TENNESSEE VALLEY AUTHORITY

In the Matter of the Application of) Docket Nos. 50-390
Tennessee Valley Authority) 50-391

WATTS BAR - UNIT 1

TABLE 4.3-2
ENGINEERED SAFETY FEATURES ACTUATION SYSTEM INSTRUMENTATION
SURVEILLANCE REQUIREMENTS

3/4 3-37

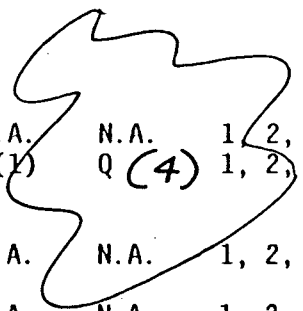
Included with the referenced exemption request were corresponding proposed revisions to the Technical Specifications. We failed, however, to include our proposed revision to technical specification page 3/4 3-37. A marked-up technical specification page 3/4 3-37 is enclosed.

A conference call was held December 5, 1984 between TVA and NRC representatives to discuss the subject exemption request. During this conference call, TVA agreed to modify its proposed revision to technical specification page 3/4 3-42 previously transmitted by the referenced November 9, 1984 letter. A marked-up technical specification page 3/4 3-42 is enclosed.

a. Manual Initiation	N.A.	N.A.	N.A.	R	N.A.	N.A.	N.A.	1, 2, 3, 4
b. Automatic Actuation Logic and Actuation Relays	N.A.	N.A.	N.A.	N.A.	M(1)	M(1)	N.A. Q (4)	1, 2, 3, 4

(4) Slave relays K603A, K603B, K604A, K604B (SI) and K625A, K625B (phase B) shall be tested during each COLD SHUTDOWN exceeding 24 hours unless tested during the previous 6 months. K609A, K609B (SI) shall be tested every 18 months.
